7 INTRODUCTION TO RESPONSE TO COMMENTS

This chapter (Chapter 7), in conjunction with the previous chapters that contain the revisions to the Draft Initial Study/Mitigated Negative Declaration (IS/MND), constitutes the Final IS/MND for the proposed Lassen Substation Project (project).

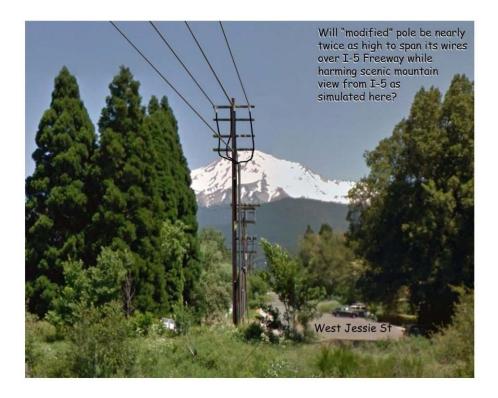
This picture below is a simulated view of this overhead power line part of this PacifiCorp/Crystal Geyser Project where it will connect to a modified power pole on the east side of the I-5 Freeway at the end of West Jessie Street:

But this view or something else that simulates what may be constructed here is not found in the PEA.

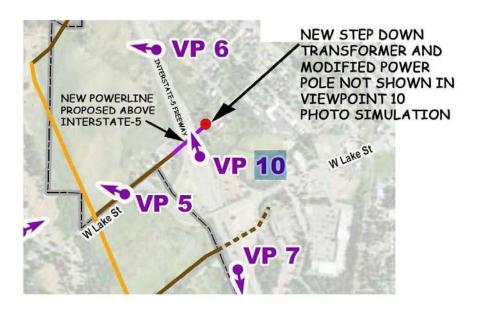
While the PEA provides a few visual simulations for views of Project infrastructure, the only two I-5 Freeway views it provides, Viewpoints 6 (to the west) and 10 (to the north), are simply not sufficient in number or extent to support PacifiCorp's conclusions on PEA page 76 of a less-than-significant visual impact. Curiously, there is no visual simulation view to the east. The PEA provides no visual simulations whatsoever to show views from this I-5 Freeway towards the Mt. Shasta peak where new power lines and modified poles will be visible!

The PEA on page 76 appears to even attempt to hide the existence or location of the proposed *modified* power pole (pole number 162400) at the west end of West Jessie Street by calling it a "modified distribution structure." The PEA makes no mention of the distance this power line will span as it passes overhead above the I-5 Freeway. Nowhere does the PEA even disclose in what way that particular pole that is so visible from the I-5 Freeway will be *modified*. Will its height be greatly increased due to the need to span the approximate 520 feet⁶ distance across the Freeway to the power pole there on West Jessie Street without having the power lines sag too close to the ground when weighted down by winter ice? The PEA's map Figure 3-5C then misidentifies West Jessie Street by labeling it "Willow St." These problems are not evidence of good faith, full public disclosure and as such violate CEQA.

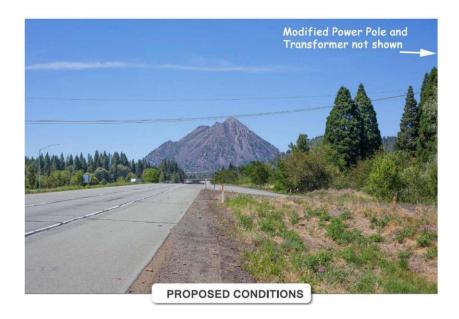
Many people may consider it to be an absurd failure when a power company with a vested interest in protecting its profits prepares an environmental assessment that ignores the most prominent visual feature (Mt. Shasta) that this PacifiCorp/Crystal Geyser Project might visually harm. Others might more suspiciously consider it an unethical cover-up to suppress damning evidence. In any case, the PEA's determination of less-than-significance regarding visual impacts is without substantial evidence absent this information.

To demonstrate that failure, consider this view from the PEA's Viewpoint 10 (on the next page) that does not include northeastern views toward the Mt. Shasta peak:

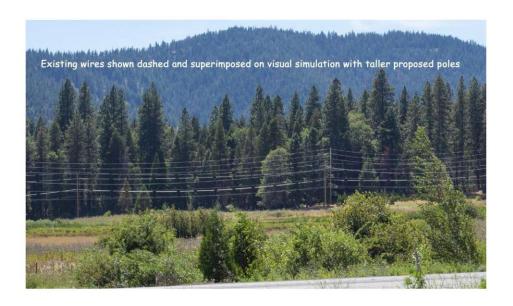
PacifiCorp is proposing to reconductor the existing distribution lines above the freeway at this location. The PEA indicates this work will occur on both sides of pole # 160901 that exists on the west side of the I-5 freeway. (See PEA, Fig. 3-5B) This figure also includes the power lines extending to the east of the I-5 freeway seen in this photo above. The PEA however makes no mention of these overhead wires being altered, enlarged or the visual impacts that may result in its list on pages 32-33 of the PEA.

This issue is critical because this is a scenic corridor that the City wants to protect by removing overhead power lines, not enlarging existing ones. The PEA fails to describe how this PacifiCorp/Crystal Geyser Project's extra power will be transmitted to Crystal Geyser's plant where the overhead wires pass above the I-5 Freeway about 120 feet south of the Lassen Lane

overpass. There is no other way for that increased power to get from the west side of the freeway to the east side. Wires on both sides of the Freeway will be enlarged. But the PEA contains no description of what exactly will occur with this scenic location. It's as if the PEA describes there will be no changes to those four existing overhead wires even though Figure 3-5B shows a brown colored line representing a "reconductored existing distribution" line extending above the Freeway. The public, when faced with inconsistency like this in the PEA, is left to conclude that this visual impact will occur and that it will not be less-than-significant as the PEA concludes.
